SITE INSTRUCTION

SI A07

PROJECT : Forestside
PROJECT # : 1331.15
DATE : Sept. 07, 2021

Title: Revisions to plans as itemized.

1:50 CS302a2

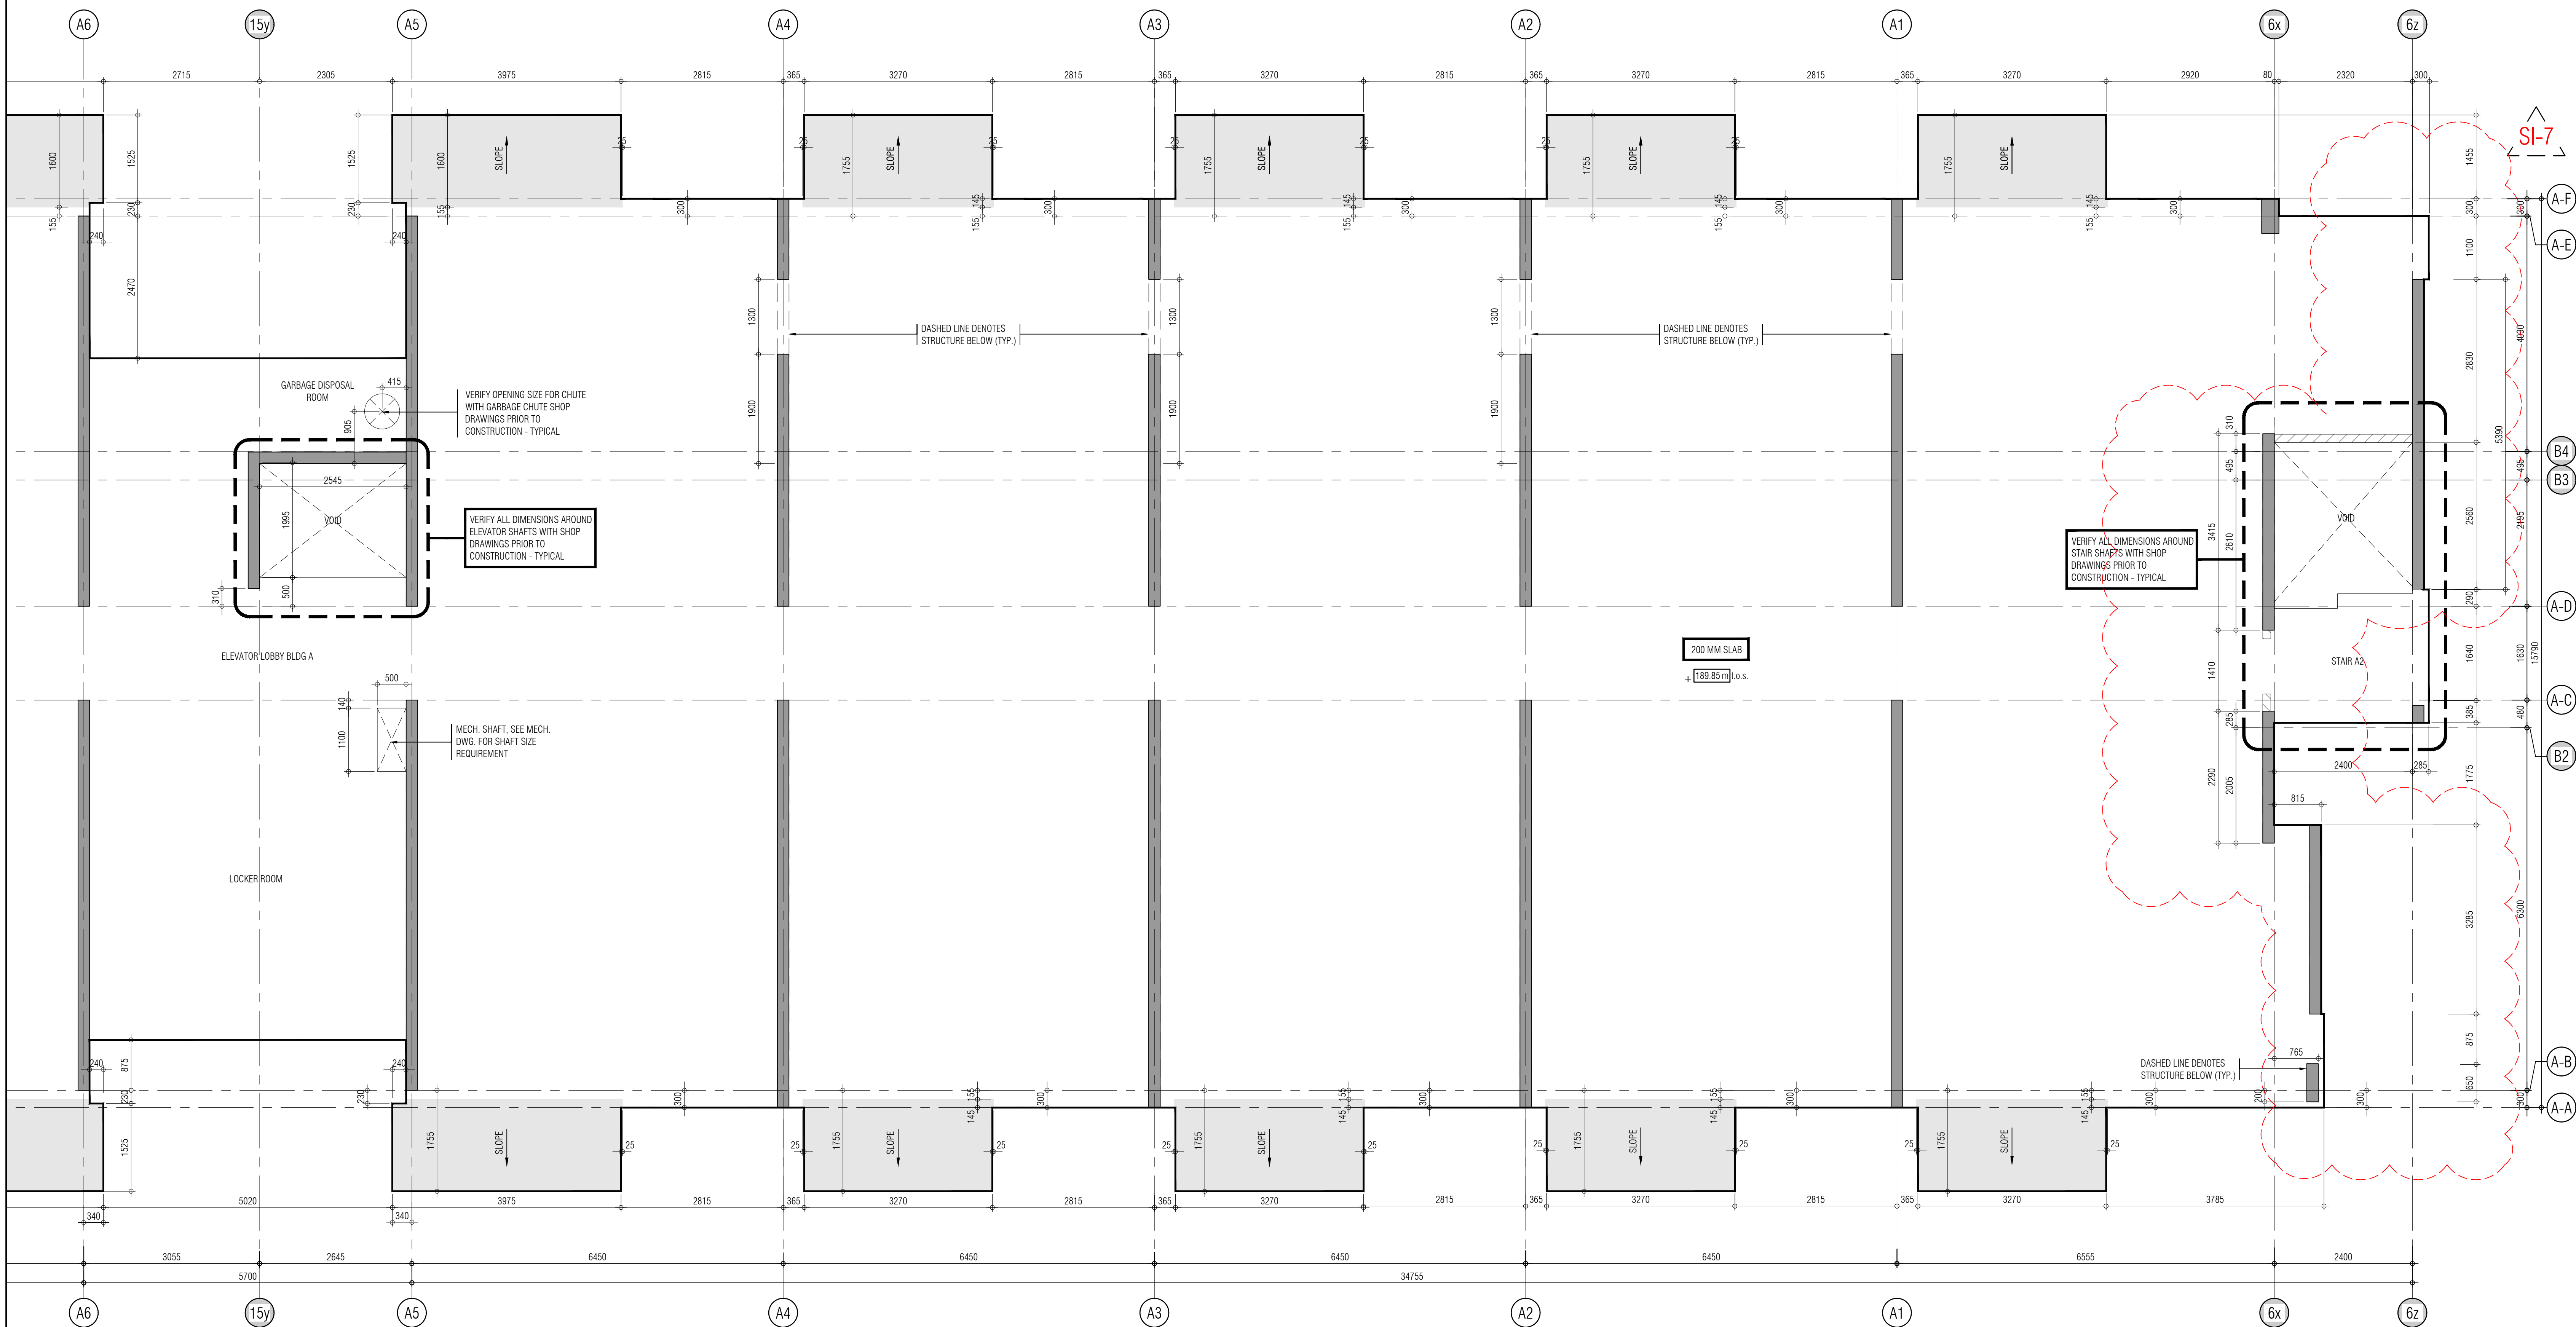
Reference:		Changes:
CS3010S, CS301A-CS303A	1st Floor to 3 rd Floor Slab Edge	Revise corner unit and stair sheer wall dimensions on Bldg. A
A301A-A303A	1st Floor to 3 rd Floor Plans	Revise corner unit and stair sheer wall dimensions on Bldg. A
